CHARLOTTE HISTORIC DISTRICT COMMISSION
CERTIFICATE OF APPROPRIATENESS - AMENDED

CERTIFICATE NUMBER: 2017-00614

ADDRESS OF PROPERTY: 617 West Park Avenue

Designed Exclusively For the:
POOVEY RESIDENCE
 617 W Park Avenue, Charlotte, NC 28203

PROPOSED FRONT ELEVATION
A-3.0
OF THIRTEEN

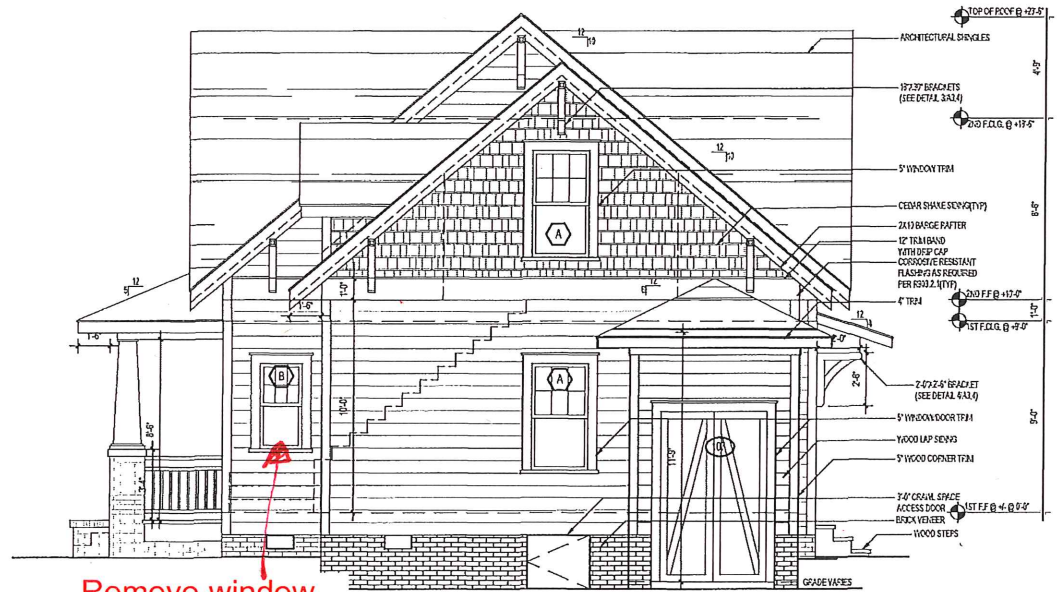
Larger window, same size as front windows (10/23/2018)

PROPOSED SITE PLAN
A-1.0
 OF THIRTEEN

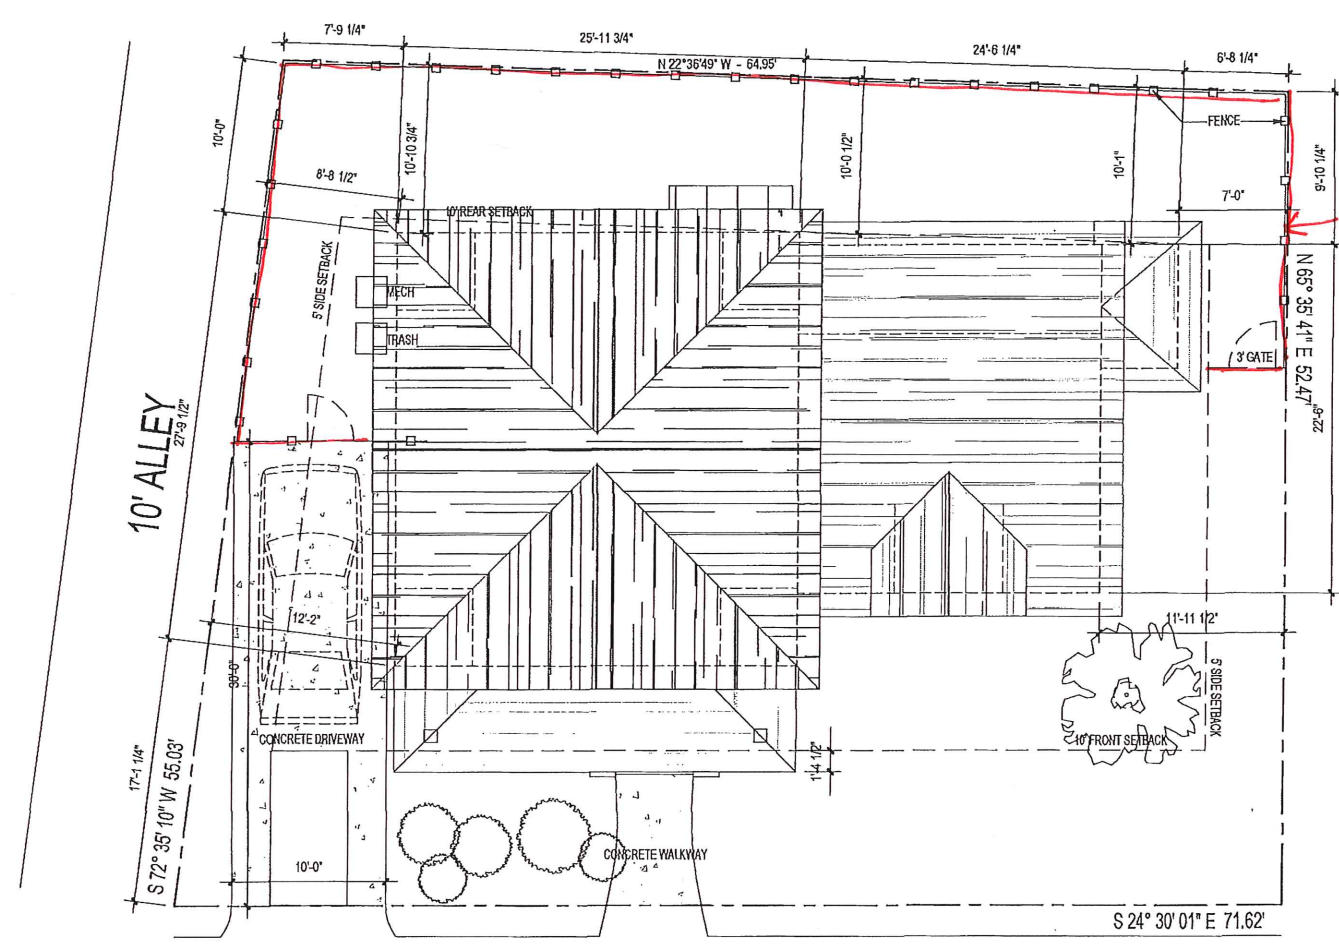
April 12, 2019 – Amendment: A wood fence will be installed around the rear yard. The fence/gates will be the shadowbox-style and all framing members will face inward to the property being enclosed or both sides will be the same. The fence will be 6' in height and will tie in at the rear corners of the house. The finished fence will be painted or stained after an appropriate curing time. See attached plans.

Fence 4/12/19

Fence Design - April 2019
